Docket Number:	23-AFC-02
Project Title:	Elmore North Geothermal Project (ENGP)
TN #:	254532
Document Title:	Elmore North Geothermal Project Data Response Set 1 (Revised Response to Data Request 31)
Description:	N/A
Filer:	Lindsey Xayachack
Organization:	Jacobs
Submitter Role:	Applicant Consultant
Submission Date:	2/16/2024 2:02:52 PM
Docketed Date:	2/16/2024

Data Response Set 1 (Revised Response to Data Request 31)

**Elmore North Geothermal Project
(23-AFC-02)**

Figure 1-2. Project location and survey coverage map.

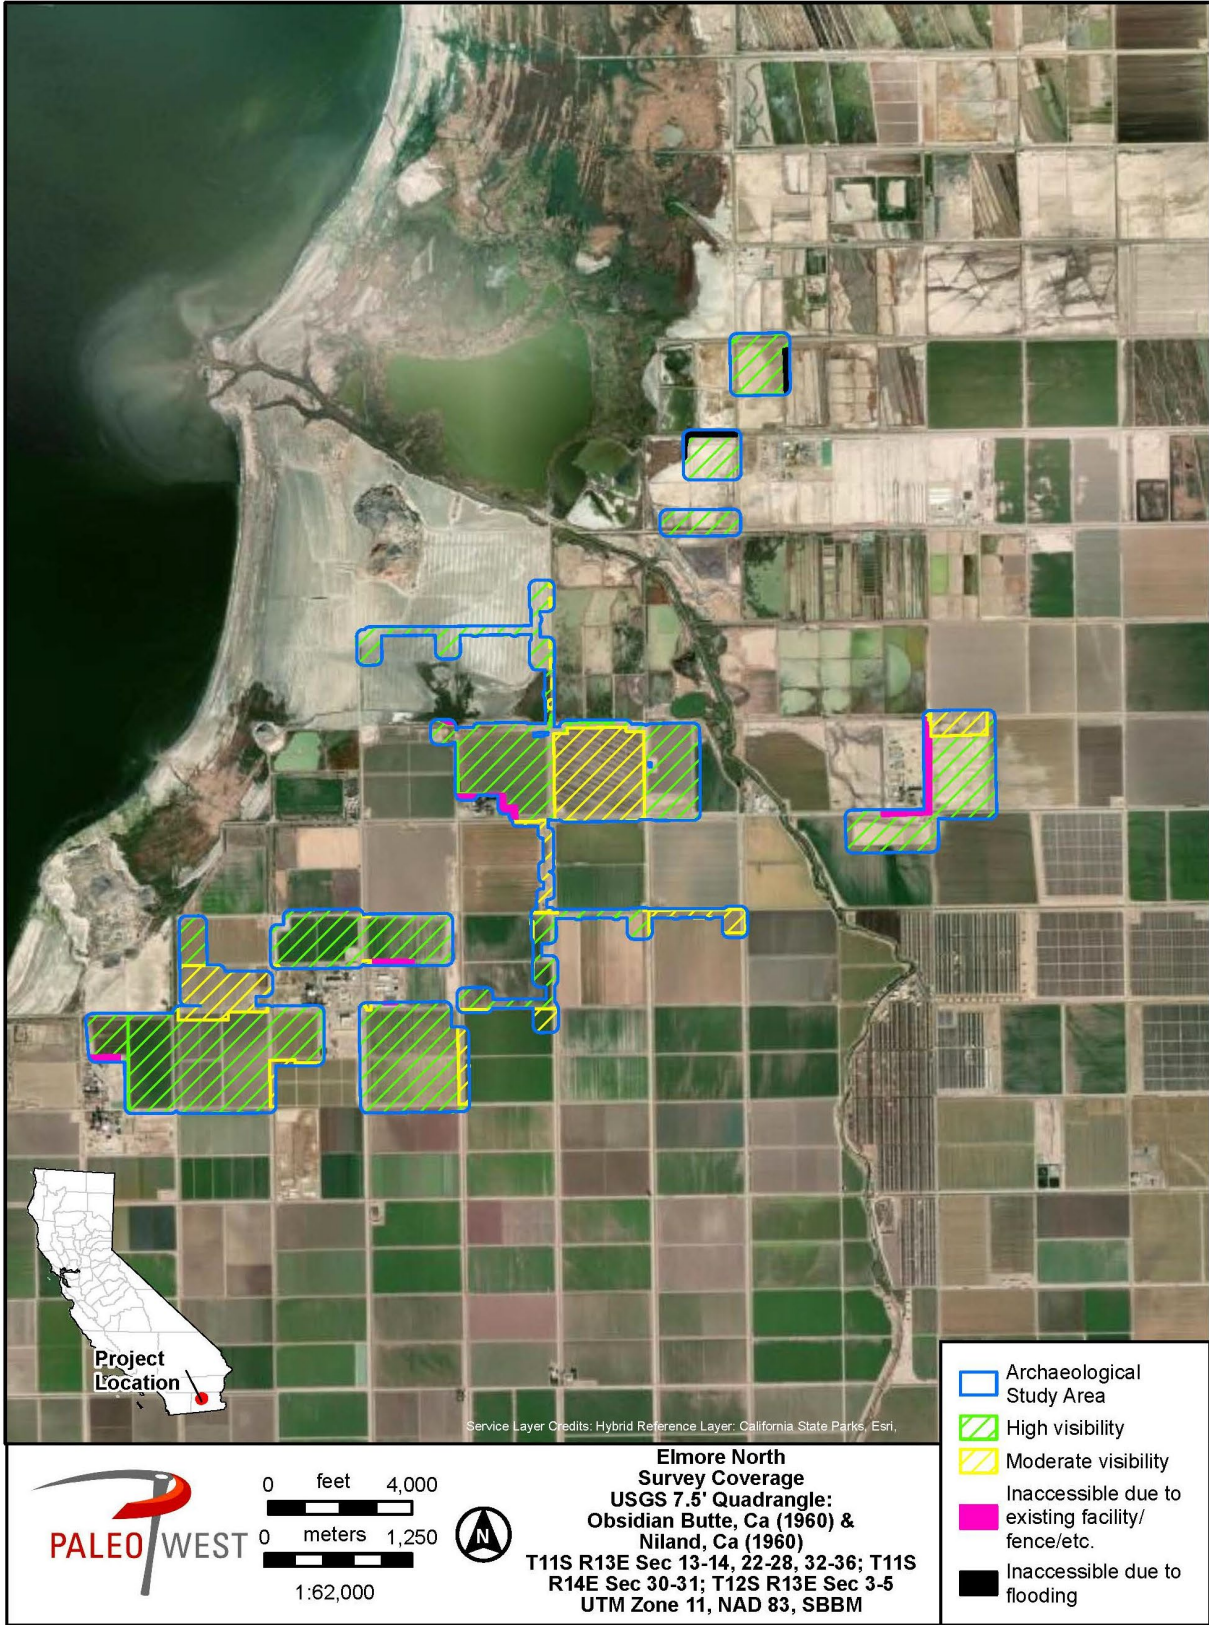
31. Please indicate when the Bermuda grass and other crops will be harvested from the low-visibility portions of the archaeological study area.

Response: The Applicant has resurveyed some areas that were previously identified as low visibility; however, areas previously obstructed by standing water remained underwater during each resurvey attempt. No new archaeological sites or isolated finds were identified. A copy of the Addendum to the Cultural Resource Technical Report for the Elmore North Geothermal Project is provided as Attachment DRR 31.

Ground visibility across the supplemental archaeological survey area varied from excellent visibility (close to 100%) to moderate visibility (25–75%). Except for 36.7 acres of land that consisted of existing geothermal facilities and 4.3 acres of land that were inaccessible due to standing water, the entire supplemental survey area was inventoried for archaeological resources. PaleoWest did not have permission to enter existing geothermal facilities; however, archaeologists were able to examine each of these areas from the perimeter fences and confirmed that the areas had been extensively disturbed by the development of the geothermal facilities.

As part of the supplemental survey, PaleoWest revisited each of the areas that was previously inaccessible due to standing water between September 12–14, November 14–16, and December 12, 2023. During all three revisits, PaleoWest archaeologists found the areas were flooded with standing water. Given that over the course of one year, the areas were consistently underwater, additional attempts to resurvey of these areas are not recommended.
